# SSCB Approved ISS External Configuration

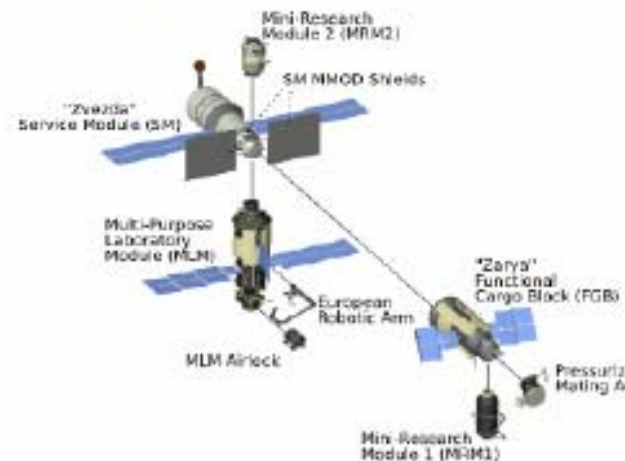
- **USOS Configuration Changes**
  - ◆ Node 3 relocated from Node 1 nadir to Node 1 port berthing mechanism and rotated to provide an nadir view for Cupola
  - ◆ Return JEM ELM-ES
- **RS Configuration Changes**
  - ◆ Mini-Research Module 2 (MRM2), a new airlock, added to SM zenith
  - ◆ Research Module replaced by Mini-Research Module 1 (MRM1) on FGB nadir
  - ◆ Docking Compartment 1, first airlock, replaced by Multi-purpose Laboratory Module (MLM) on Service Module (SM) nadir port
  - ◆ MLM includes experiment airlock, radiator, European Robotic Arm (ERA) spare elbow, work platform relocated from FGB nadir to SM nadir port
